CONSTRUCTION DRAWINGS FOX RUN NATURE CENTER

EPC STORMWATER REVIEW COMMENTS
IN ORANGE BOXES WITH BLACK TEXT

SHEET INDEX	
SHEET NUMBER	SHEET TITLE
C1	COVER
C2	EXISTING CONDITIONS & DEMO PLAN I
C3	EXISTING CONDITIONS & DEMO PLAN II
C4	SITE PLAN
C5	SIGNING & STRIPING PLAN
C6	DRIVEWAY & PARKING AREA GRADING PLAN
C7	BUILDING GRADING PLAN
C8	ROAD RECLAMATION GRADING PLAN
C9	WALL PLAN AND PROFILE I
C10	WALL PLAN AND PROFILE II
C11	WALL PLAN AND PROFILE III
C12	WALL PLAN AND PROFILE IV
C13	UTILITY SERVICES PLAN
C14	OFF-SITE WATER SYSTEM PLAN
C15	ON-SITE WATER SYSTEM PLAN
C16	OVERALL STORM SYSTEM PLAN
C17	ROOF DRAIN AND PATIO PLAN AND PROFILE
C18	POND PLAN AND PROFILE
C19	DETAILS

EL PASO COUNTY
FOX RUN NATURE CENTER
SITE PLAN

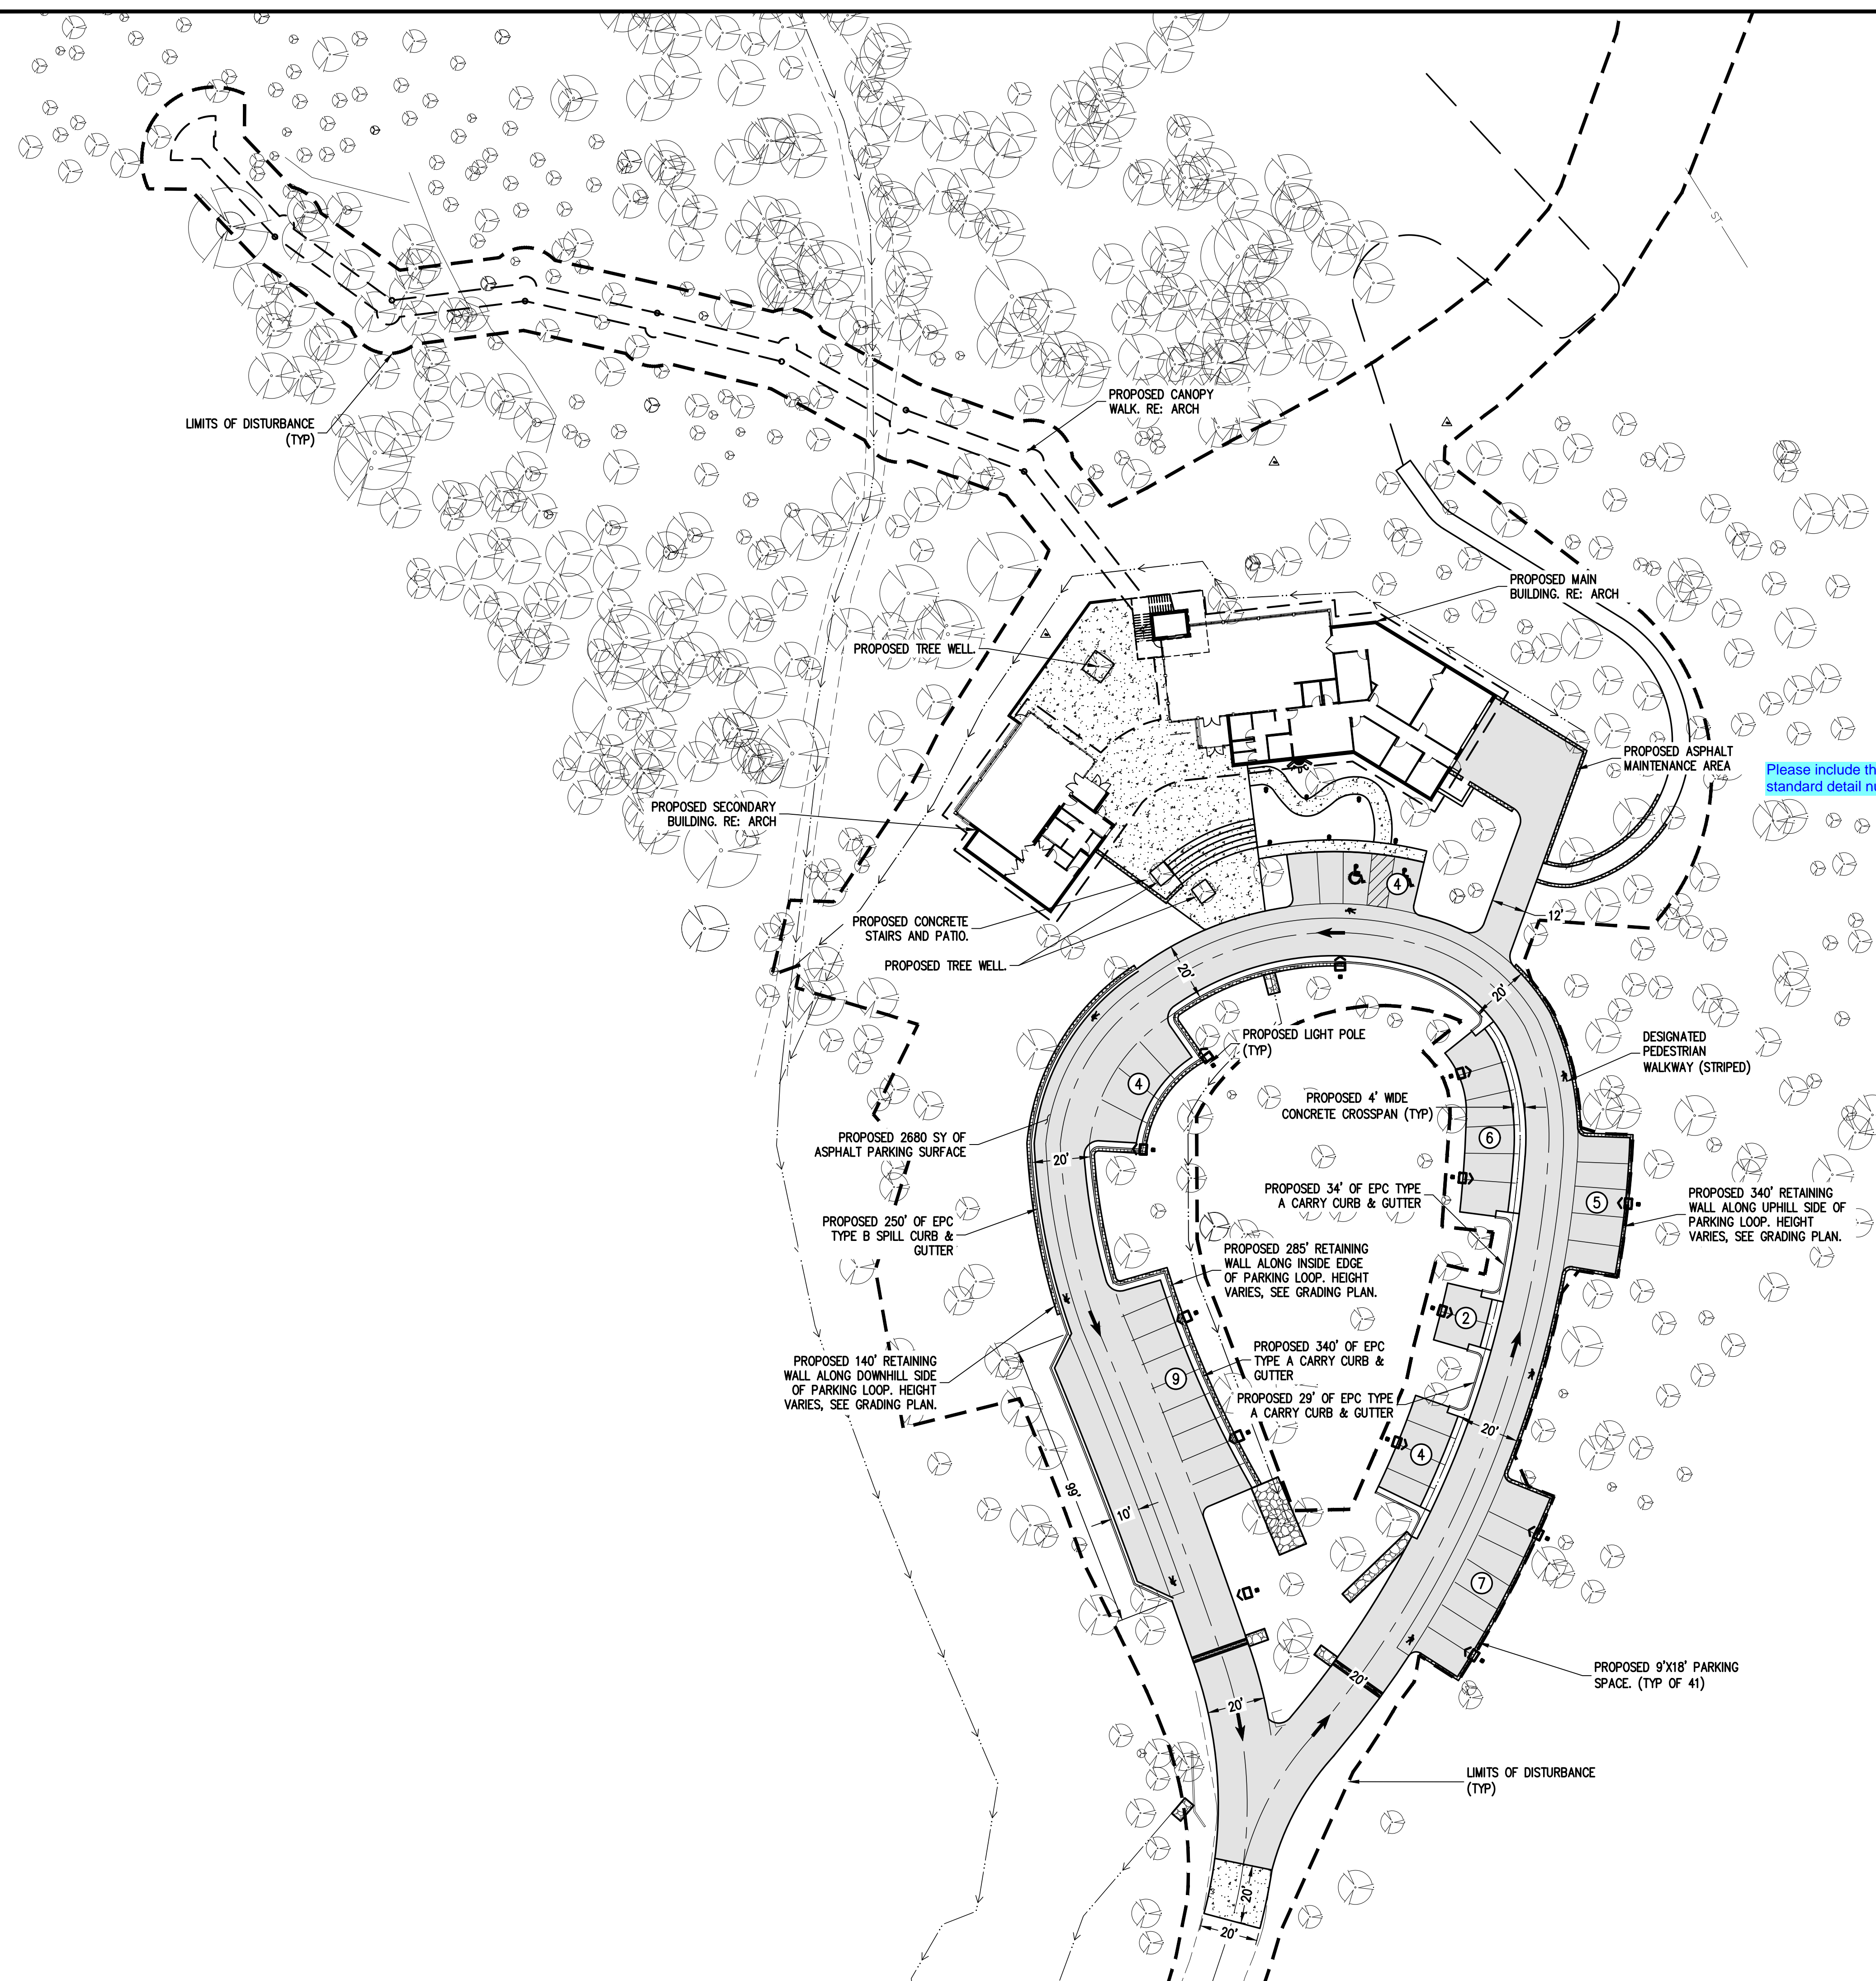
Please include the standard detail number

EL PASO COUNTY
FOX RUN NATURE CENTER
SIGNING & STRIPING PLAN

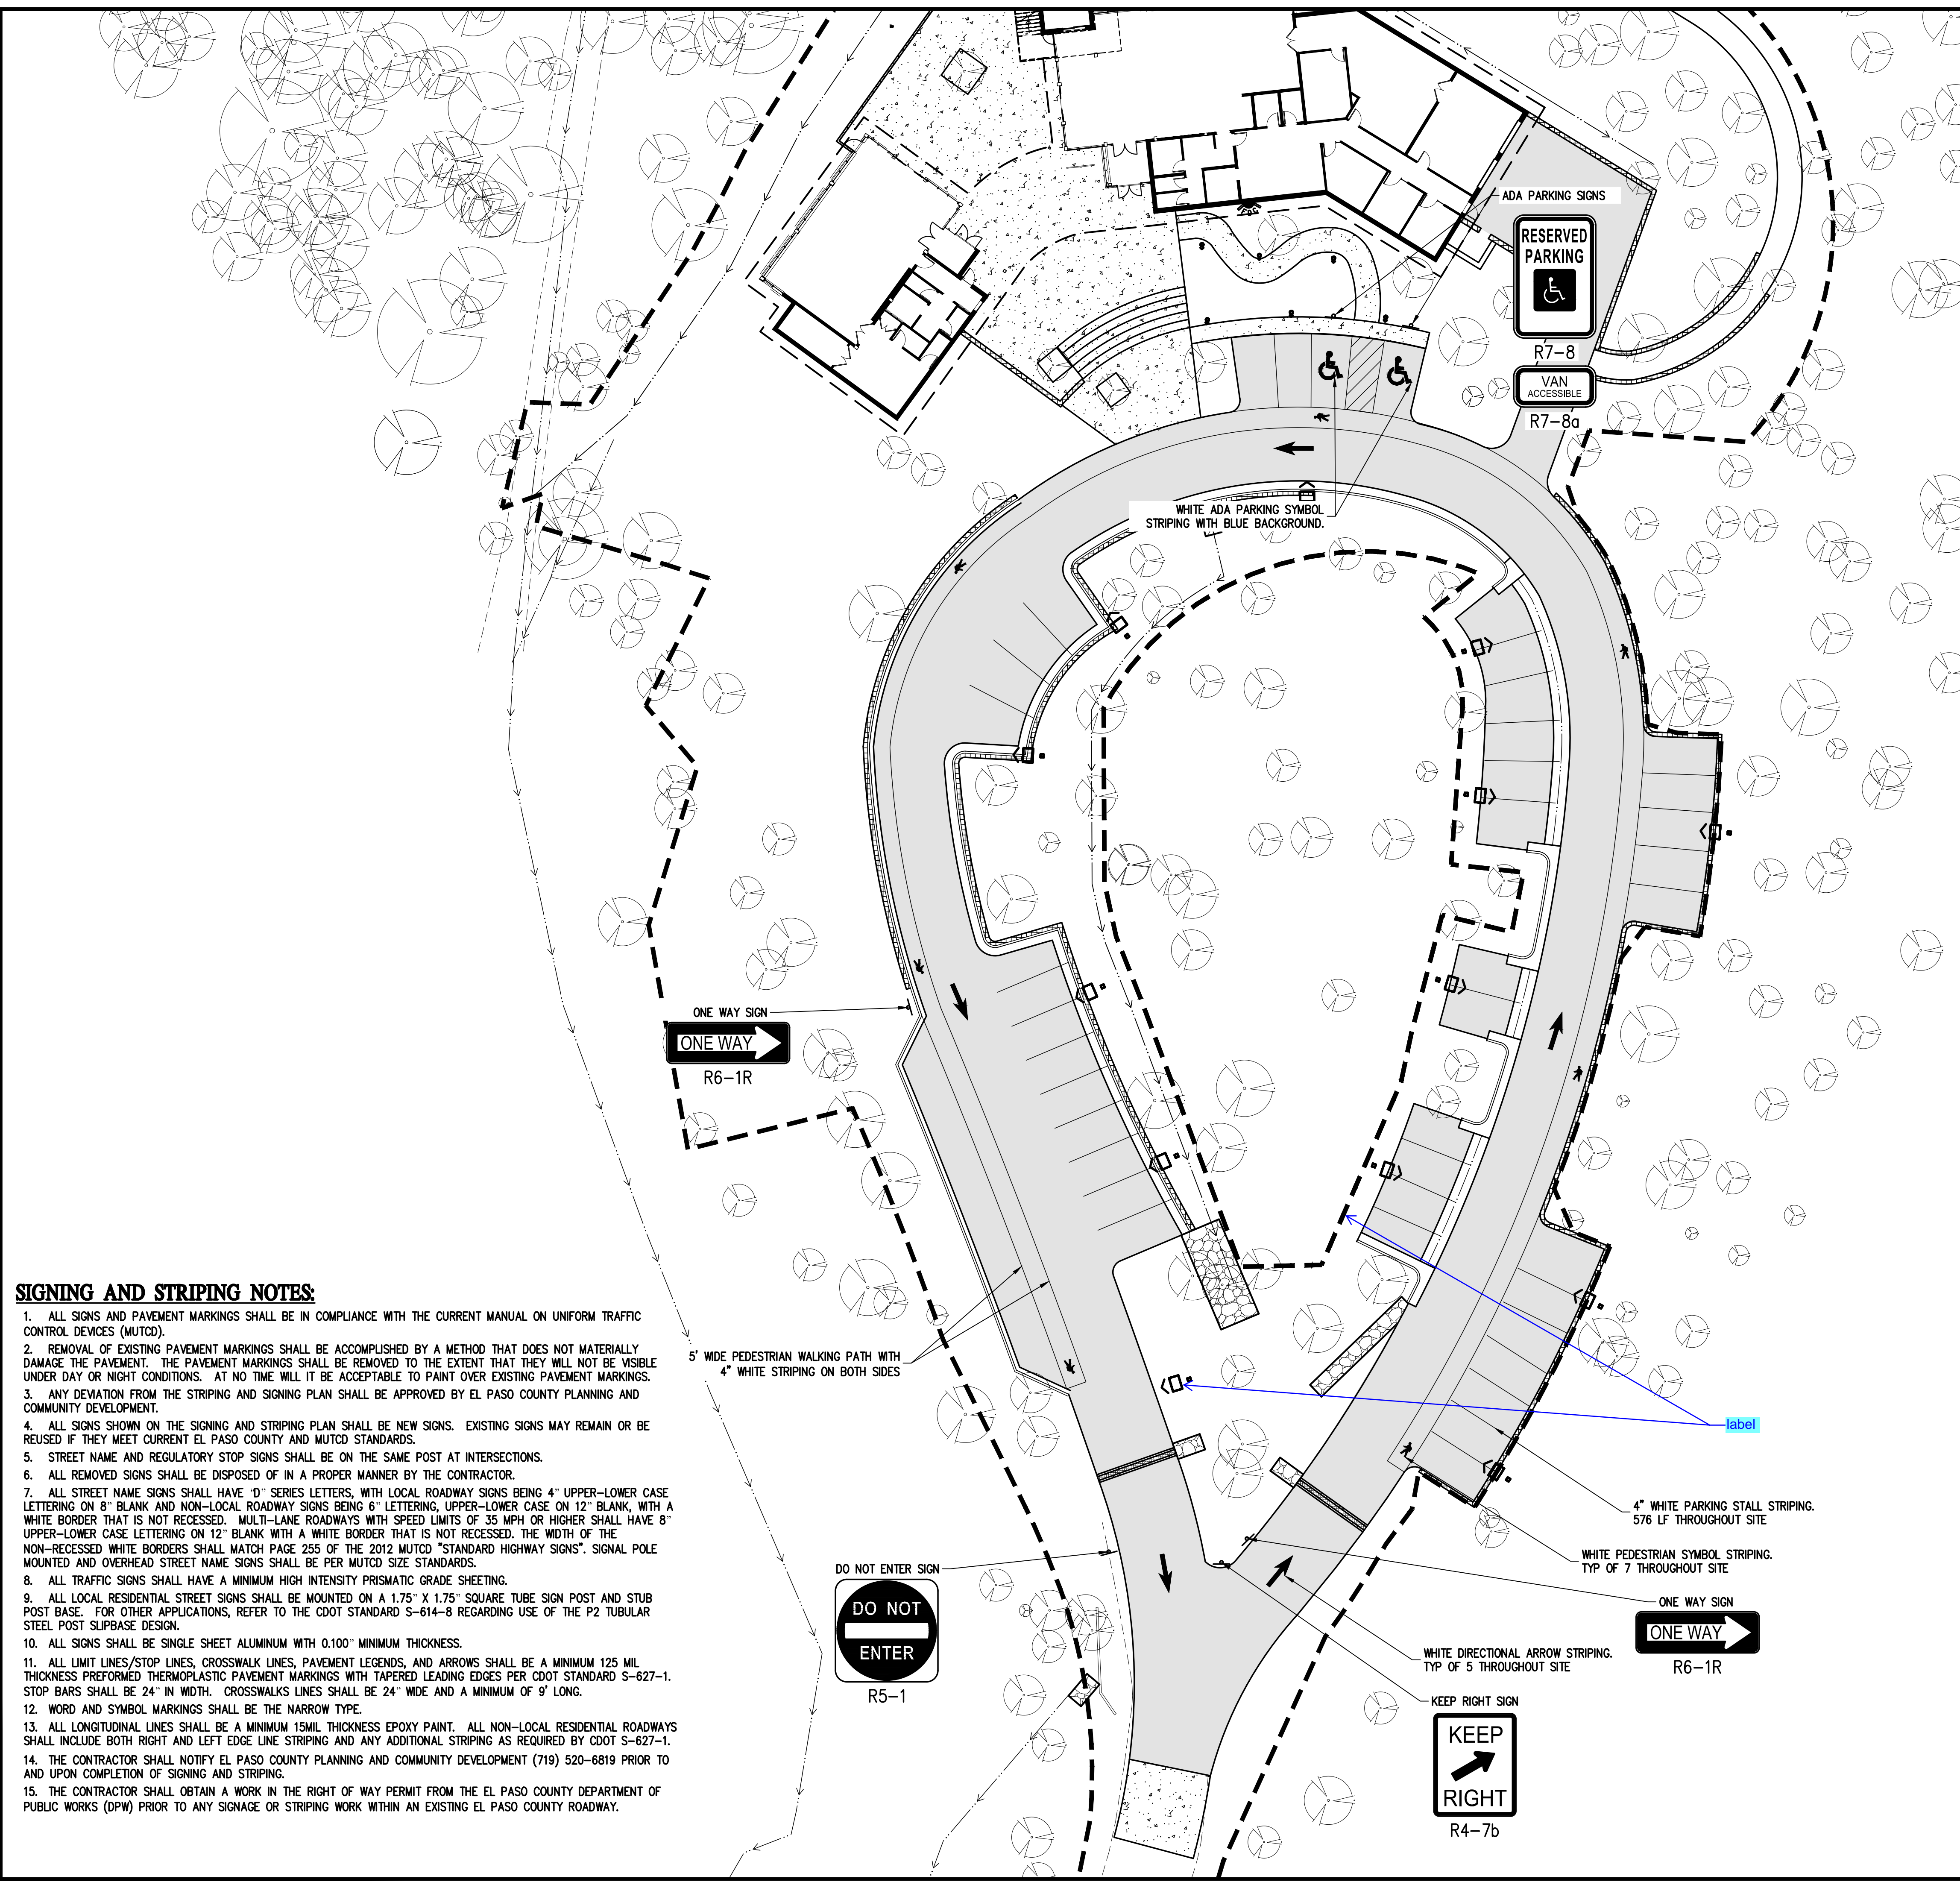
Turn off unneeded items to improve clarity of drawing
